INFORMATION BULLETIN

September 1, 2005

AUXILIARY EXHAUST SHIELD

All models of the Honda powered Prop/Jet, Model FPJ-4-P used on bumper boats.

AUXILIARY EXHAUST SHIELD INSTALLATION PROCEDURE

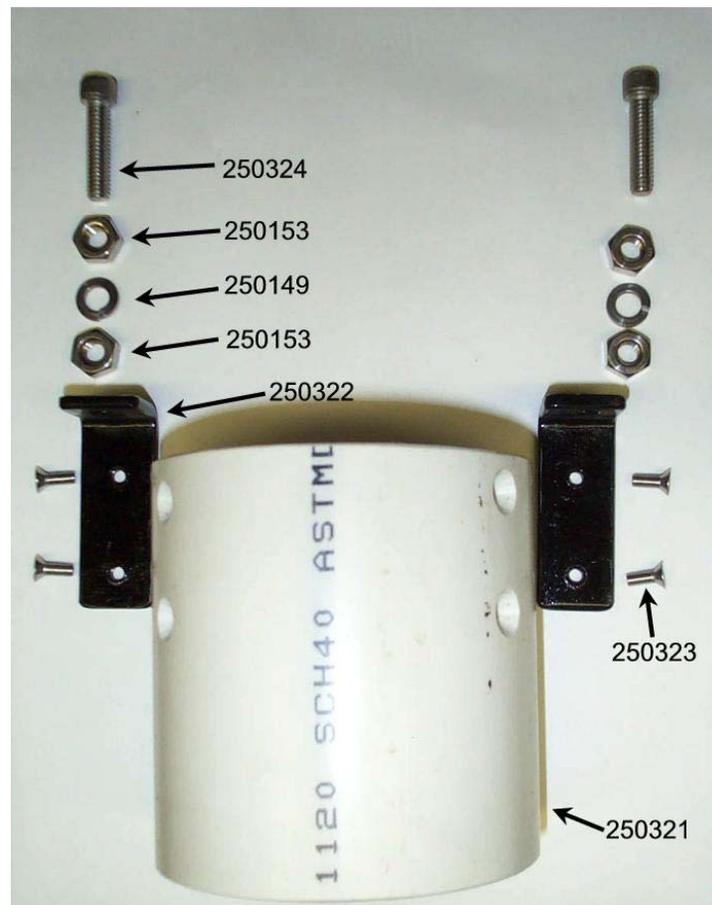
Note: The auxiliary exhaust shield will be installed to the Prop/Jet engine by using existing drainage holes and supplied hardware.

Step 2) Locate the (2) drainage holes nearest the exhaust tube. Place the (2) bolts (# 250324), through the holes and loosely tighten the nuts (# 250153) onto the bolts.

Step 3) Install brackets (# 250322), lock washers (# 250149), and Nuts (# 250153) on bolts (# 250324). DO NOT TIGHTEN

Step 4) Align auxiliary exhaust shield (# 250321), and install the screws (# 250323).
